ADDENDUM NO. 1

DATE: July 1, 2021
FROM: City of Grand Junction Purchasing Division
TO: All Interested Parties
RE: RTU Replacement Persigo WWTP IFB-4923-21-SH

**PERSIGO TREATMENT PLANT
LABORATORY RTU REPLACEMENT**
2145 RIVER ROAD
GRAND JUNCTION, COLORADO

SHEET NUMBER:
M1-1

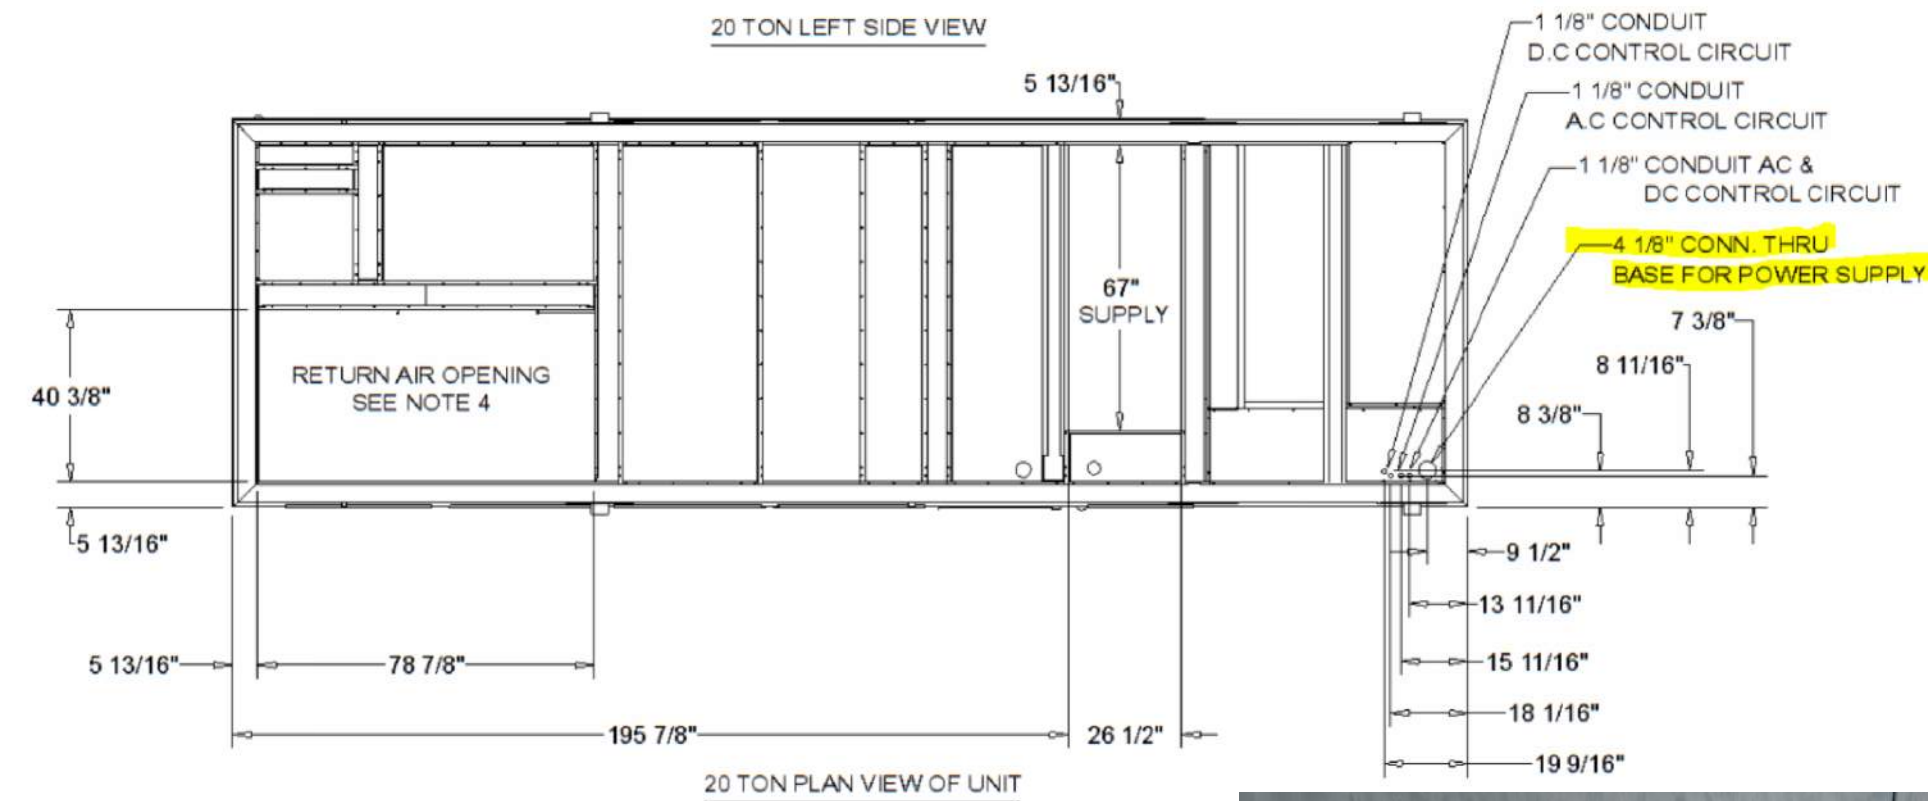
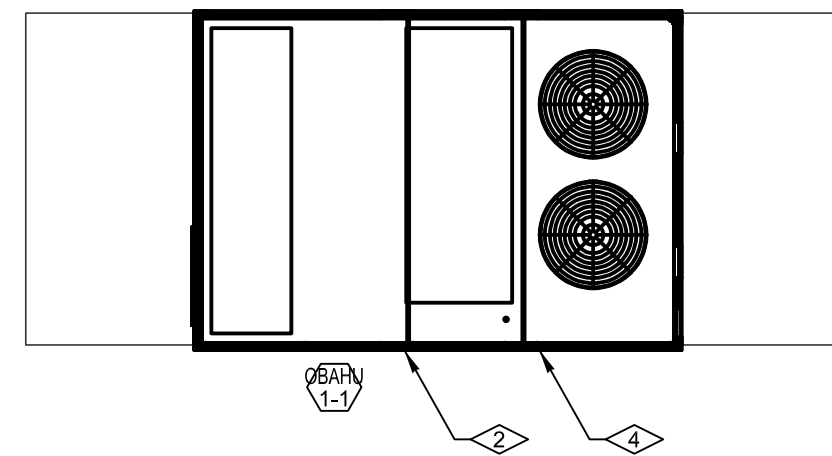
1. **Attached Drawings M1-1 and M1-3 are attached to reflect changes noted below. Photos and cutsheet excerpts have been added to the drawings.**
2. **Base Bid Clarification:**
AC-1
Remove existing Trane PCM Control Panel. Provide with standalone DDC Controller capable of controlling all the RTU's functionality requirements. Controller shall also modulate existing heating water control valve and energize the glycol coil pump upon a call for heating. Controller shall be provided with a BACnet card for future integration into a web based enable front end building automation system. It has been confirmed the existing and proposed AC-1 RTU through the base power and piping connections are in the same locations.

NEW LABORATORY TRANE INTELLIPAK THROUGH THE BASE PIPING CONNECTIONS

EXISTING LABORATORY TRANE INTELLIPAK THROUGH THE BASE PIPING CONNECTIONS

NEW LABORATORY TRANE INTELLIPAK THROUGH THE BASE POWER CONNECTION

EXISTING LABORATORY TRANE INTELLIPAK THROUGH THE BASE POWER CONNECTION

DATE:	06/02/2021
JOB NO.:	21-077
DRAWN BY:	BCE
CHECKED BY:	BCE
SCALE:	AS SHOWN
SHEET NUMBER:	M1-3

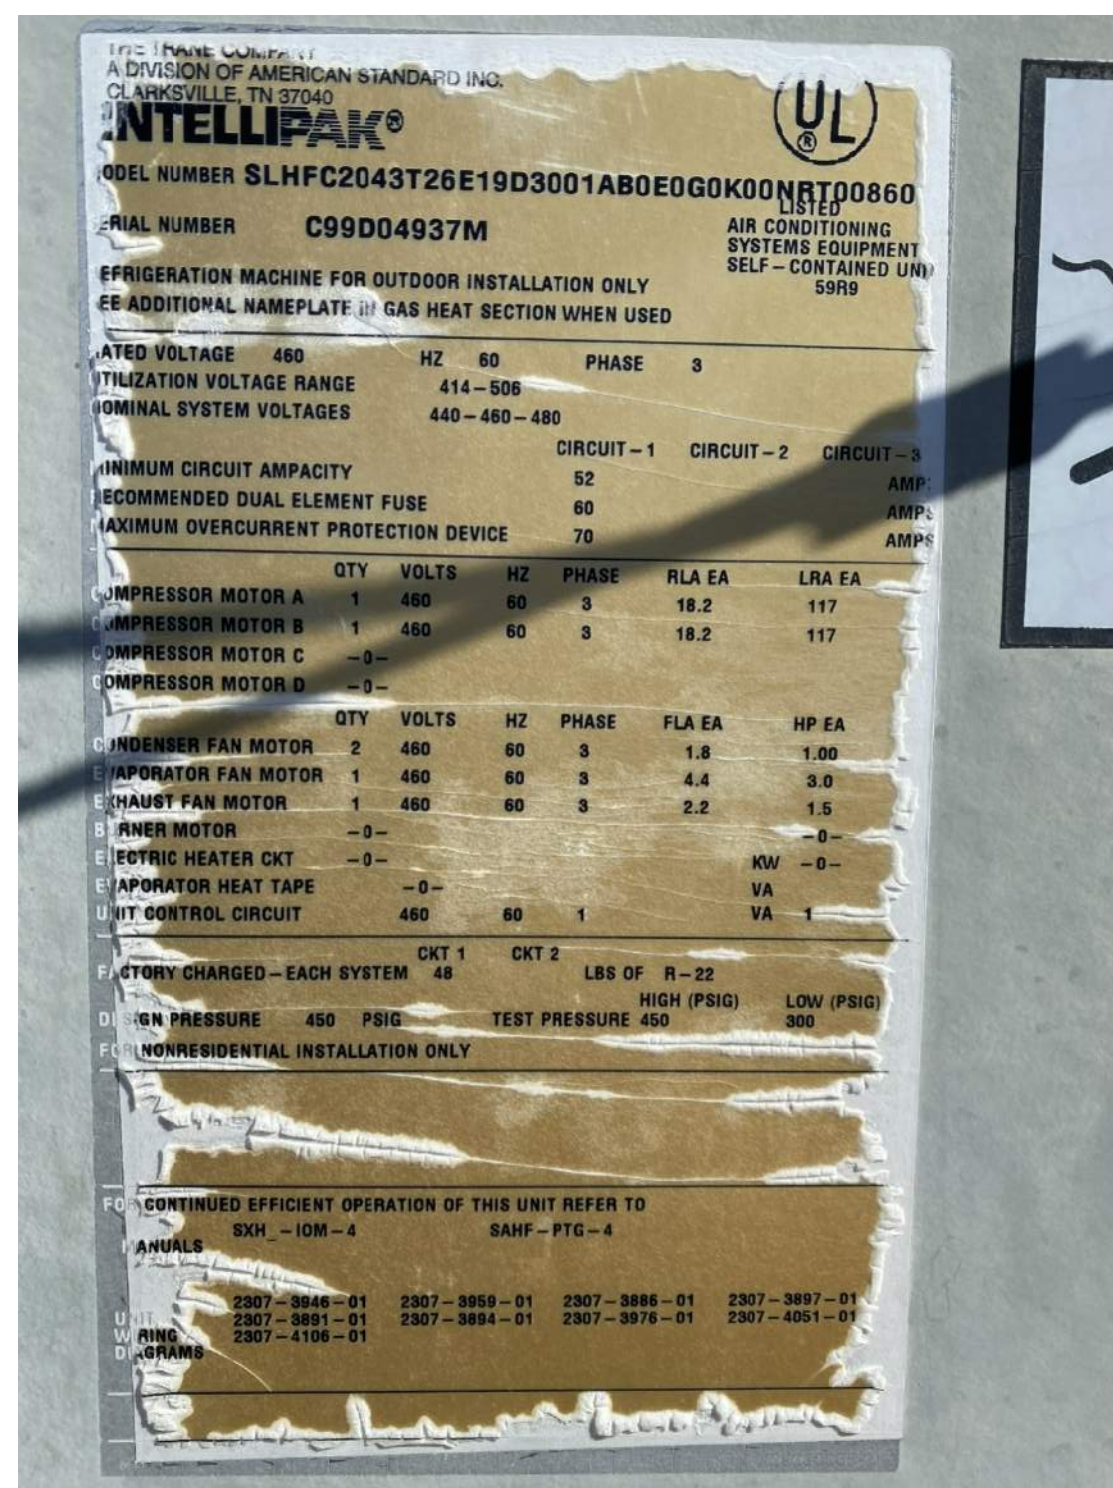
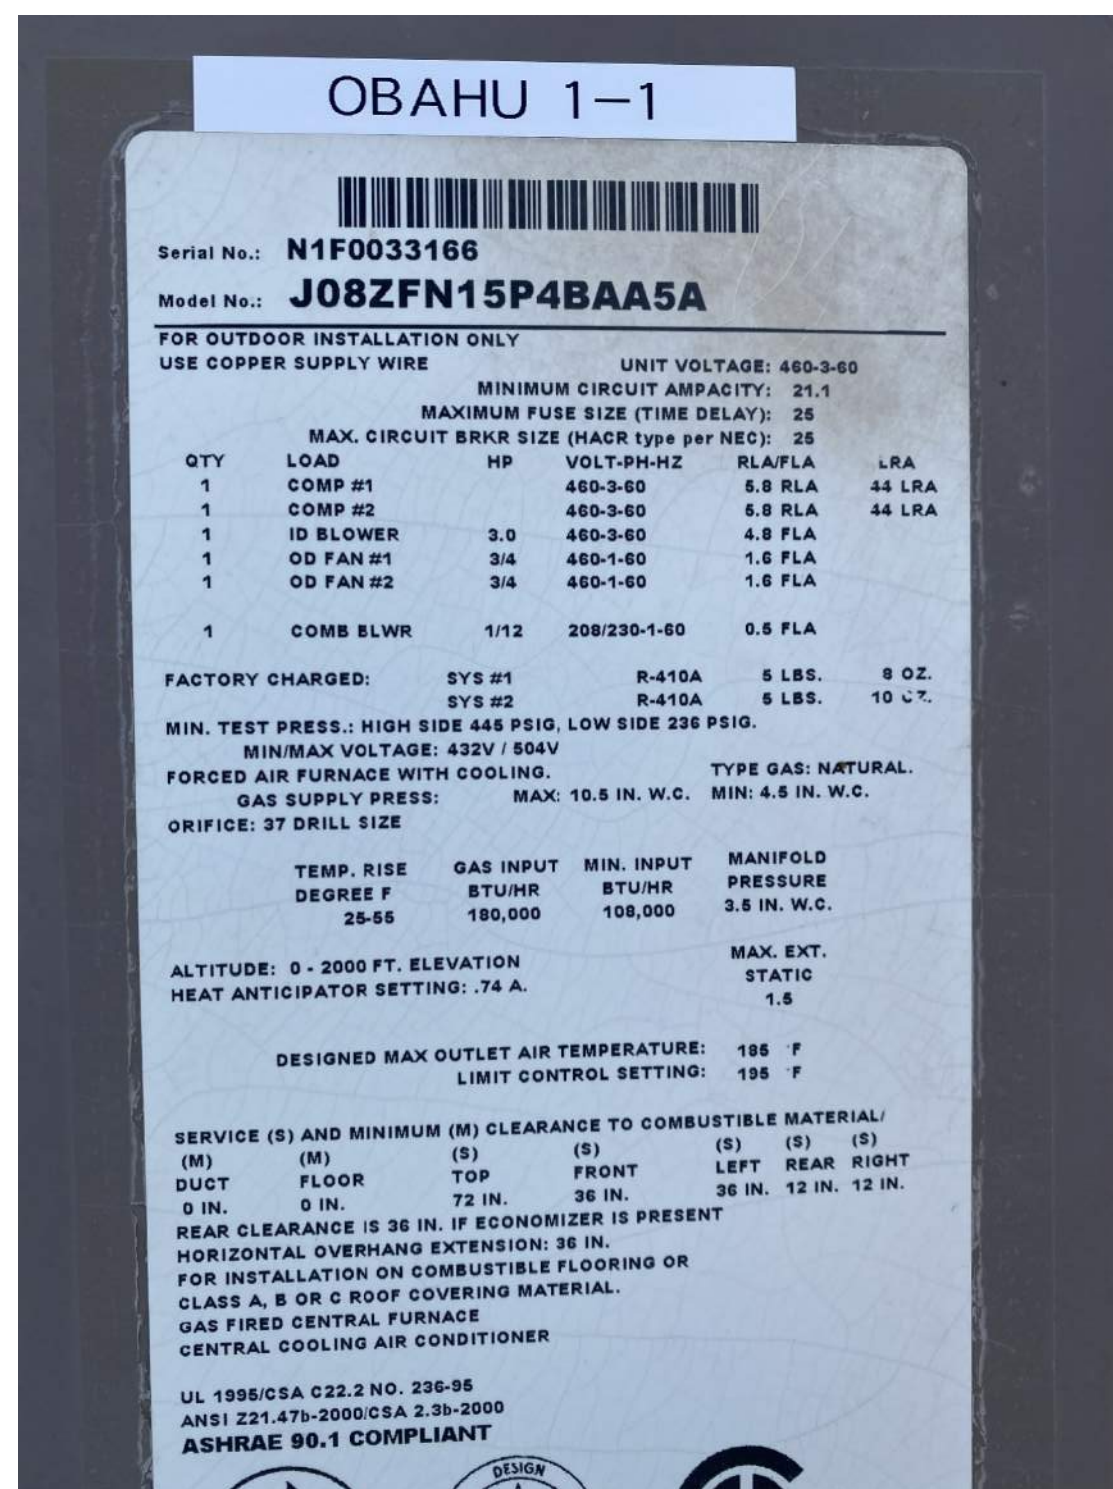
3. **Base Bid Clarification:**
OBAHU 1-1
Remove existing Johnson Controls panel. Provide with standalone DDC Controller capable of controlling all the RTU's functionality requirements. Controller shall also control operation of the three (3) existing thermostatically controlled zone dampers. Provide with components, accessories, and controls for demand control ventilation. Controller shall be provided with a BACnet card for future integration into a web based enabled front end building automation system.

OBAHU 1-1
REMOVE EXISTING JOHNSON CONTROLS PANEL. PROVIDE WITH STAND ALONE DDC CONTROLLER CAPABLE OF CONTROLLING ALL OF THE RTU'S FUNCTIONALITY REQUIREMENTS. CONTROLLER SHALL ALSO CONTROL THE OPERATION OF THE (3) EXISTING THERMOSTATICALLY CONTROLLED ZONE DAMPERS. PROVIDE WITH THE COMPONENTS, ACCESSORIES, AND CONTROLS FOR DEMAND CONTROL VENTILATION. CONTROLLER SHALL BE PROVIDED WITH A BACnet CARD FOR FUTURE INTEGRATION INTO A WEB BASED ENABLED FRONT END BUILDING AUTOMATION SYSTEM.

DDC CONTROL NOTES ADD ALTERNATE #1:
IN ADDITION TO THE TRACER SC CONTROL PANELS PROVIDED WITH AC-1 AND OBAHU 1-1 TO PROVIDE FUNCTIONALITY OF EACH UNIT, THE CONTRACTOR SHALL PROVIDE AND INSTALL A TRANE TRACER SC+ BUILDING AUTOMATION SYSTEM USING THE TRACER SYNCHRONY USER INTERFACE. THE SYSTEM SHALL BE FULLY WEB-BASED ENABLED AND SHALL CONTROL AND INTERFACE WITH ALL ASPECTS OF THE NEW ROOFTOP UNITS AC-1 AND OBAHU 1-1.
